UNITED STATES PATENT AND TRADEMARK OFFICE

10/591,728

Office Action Summary	Application No. 10/591,728	Applicant(s) MANDT ET AL.	
	Examiner Lucas Stelling	Art Unit 1797

DETAILED ACTION

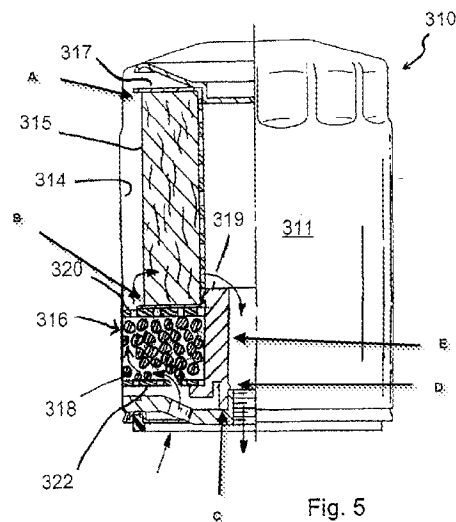
6. As to claim 1, Rohrbach teaches a service cartridge for positioning in a filter housing; the service cartridge comprising:

filter media **(315)** having a first and second ends **(A and B)** and positioned around a central opening area;

a first end cap **(part of the frame 317 constitutes an end cap of the filter)** secured to the first end of the filter media; and ,

a treatment agent storage and release cartridge **(the cartridge is defined by the upper plate 320, the lower plate 322, the sealing member 319, see also [0055], [0056], and [0057])** to the second end of the media;

the treatment agent storage and release cartridge having a ring configuration **(the filter is cylindrical)** defining an inside wall **(E)** defining a central flow conduit in liquid flow communication with the central open area defined by the filter media;

the inside wall having no diffusion apertures **(no diffusion apertures are show through the inside wall)** therethrough; and

a housing seal arrangement **(see C and D)**.

9. As to claim 2, Rohrbach and Paul teach the device of claim 1, and Rohrbach shows a service cartridge where the cartridge inside wall seals to the housing in a radial configuration **(See C and D above).**
